Minnesota Highway Department

PROPOSED MEDIAN BR. 9340

Bridge No. 9340
 Made by R.R.T.
 Checked by _____
 Sheet No. 1 of 1
 Date 8-9-63
 DRN. 8-9-63 T.J.H.

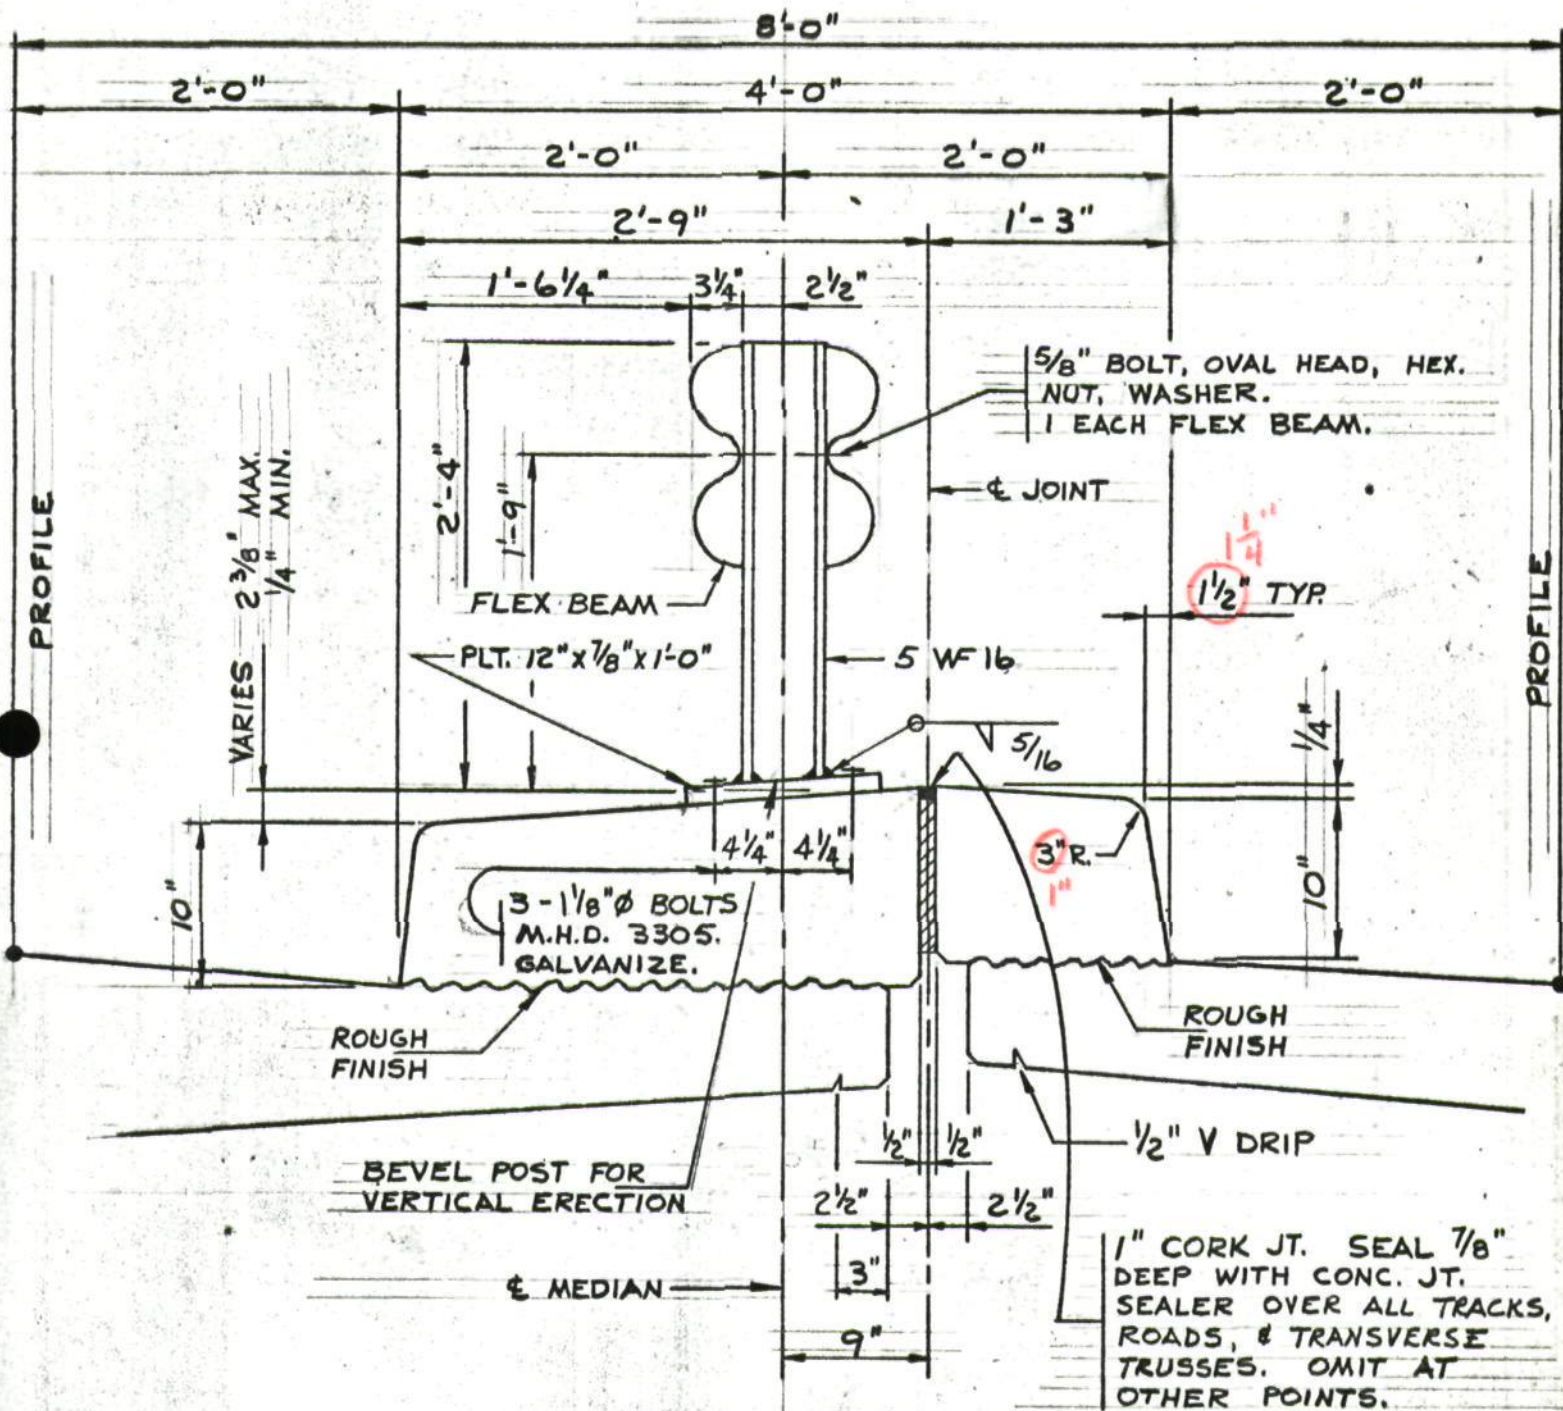
Median will be sloped as shown below

New median detail dated 7-26-63 was given to consultant. It was decided that the longitud. joint would run the entire length of bridge, and offset 9" from \pm . This would place the joint west of the \pm on the South portion of Br. and East of \pm on the North portion of Br. A detail showing how the median slopes is attached.

SKIN FRICTION

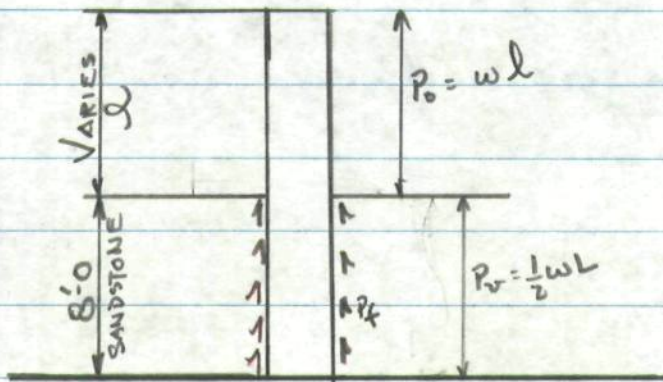
AEL would like an estimate of skin friction

In a cohesionless material

$$P_f = \pi D L p \tan \phi$$

Use $L = 8'$

$P_f = \pi \times 4.0 \times 8.0 \times .4 \times \tan 30^\circ = 23.1 \text{ KIPS}$

$f_a = \frac{23100}{12.56} = 1839 \text{ psi}$
